TECHNICAL EVALUATION REPORT

EVALUATION OF SPENT FUEL RACKS STRUCTURAL ANALYSIS

DUKE POWER COMPANY

McGUIRE NUCLEAR STATION UNITS 1 AND 2

Figure 3. Two-Dimensional Nonlinear Model

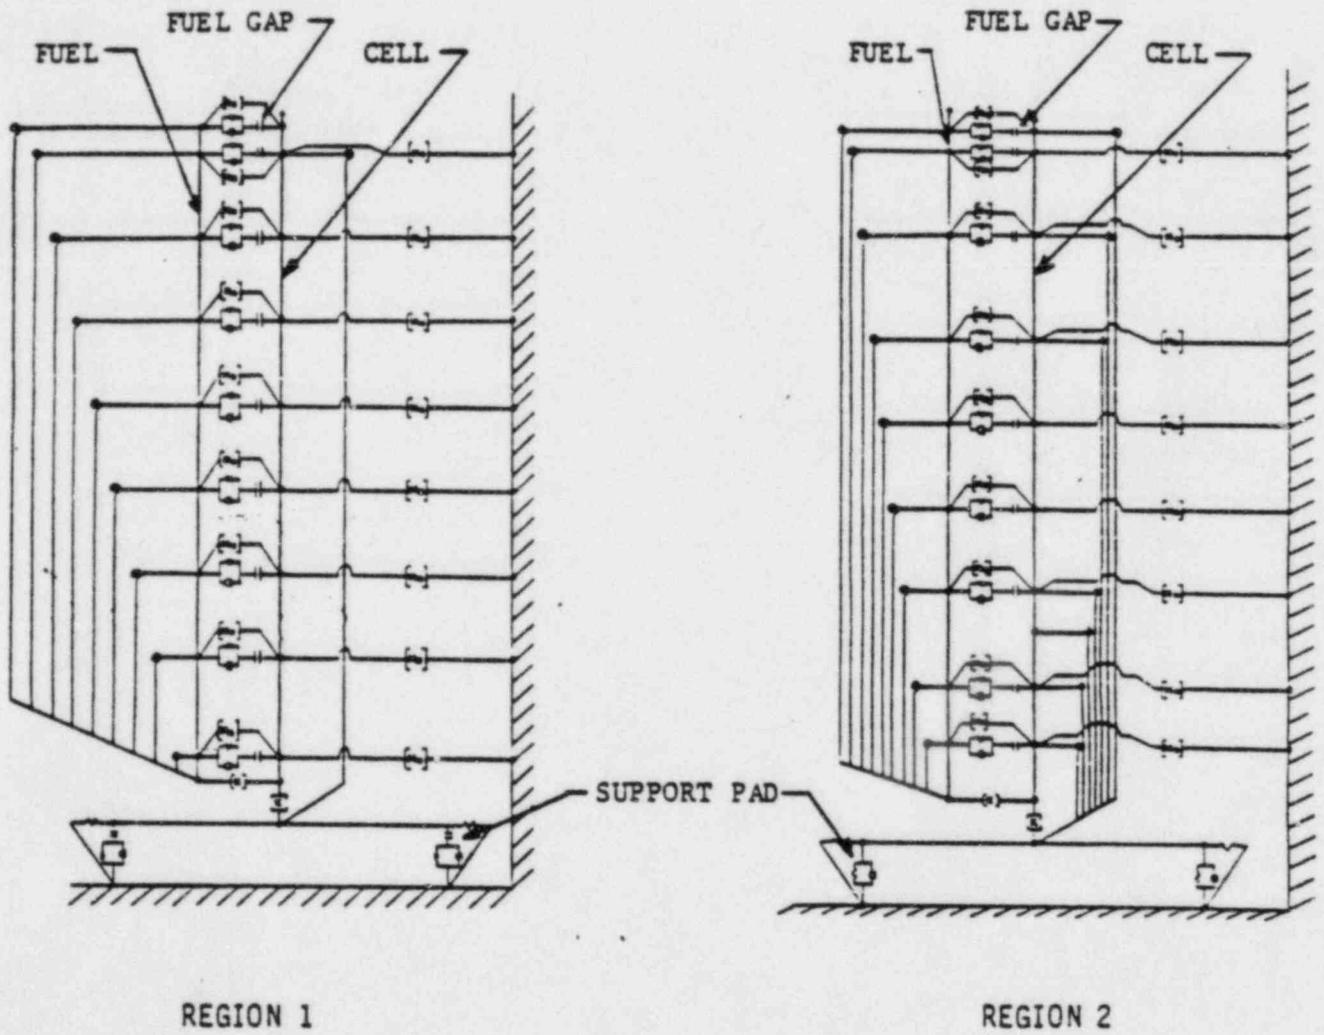
The simplified two-dimensional model does not fully simulate the more complicated three-dimensional structure behavior exhibited by the modules. The two-dimensional model essentially uncouples the two mutually perpendicular horizontal motions which are nonlinearly interrelated under seismic loadings. Thus, an approach using two models (nonlinear, two-dimensional and linear, three-dimensional model) may have difficulty in resolving peak stresses.

The value of impact damping (15%) used in the analysis was questioned when documentation of the damping values provided by the Licensee confirmed a range of only 10% to 15% [4]. However, the Licensee has submitted the following response which cites test data performed by Babcock & Wilcox Company (fuel suppliers) which is stated to be on file with the USNRC [5]:

Since damping influences the amplitude of dynamic response, it is important to use values that do not overestimate the energy loss of the system.

The assumption in Item d may be valid when adjacent modules are fully loaded, but the out-of-phase response will most likely occur when some modules are either partially loaded or empty.

"In determining the fuel assembly impact damping, B & W performed a series of tests. The upper and lower bounds for the tests are reported as .1462 and .1650 respectively with a median value for all tests of .1565. B & W Topical Report 10133P Rev. 1, filed with the NRC on 5/3/79, gives a fuel assembly impact damping value of 16% for a Mark C assembly. The report also notes that B & W Mark C characteristics are similar to the B & W Mark B assembly characteristics which are stored at McGuire, thus, the results are directly comparable. The Applicant maintains that use of a damping value of 15% is appropriate and the conservatism of the analytical results used in the design of the proposed racks are preserved."

Figure 4. Three-Dimensional Linear Model

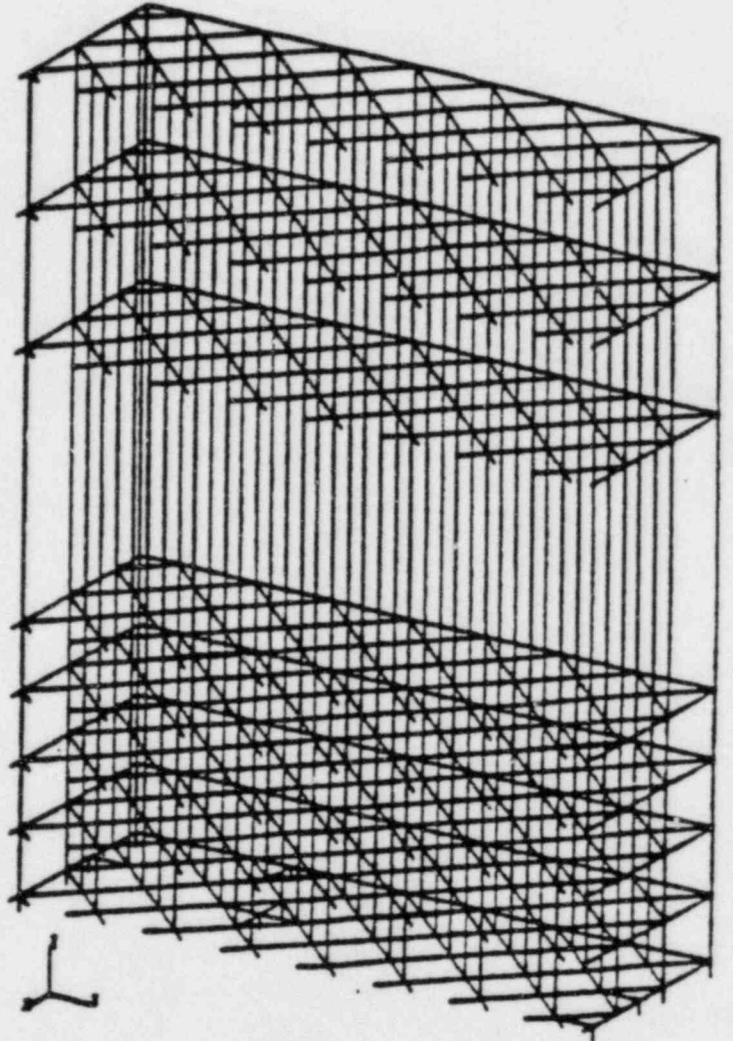
The three-dimensional linear model is a comprehensive model that is suitable for predicting stresses in all regions of the rack module. However, it is a linear model in which the fuel assembly masses are included directly with the rack masses without any consideration for their moving through clearance spaces and impacting the rack structure. Neither are the mounting feet considered to slide or impact vertically following a lift-off, should it occur. However, as a linearized model of the spent fuel rack module for internal stress analysis purposes, the three-dimensional model was reviewed and found to be acceptable.

- o The three-dimensional stress analysis, the results of which are ratioed by the load correction factors from the two-dimensional, nonlinear analyses, still analyzes one earthquake direction at a time. Thus, the maximum stress at a point must be computed as the square root of the sum of the squares of the separate values for each earthquake direction. Peak stresses due to sharp impact forces may not be resolved well.
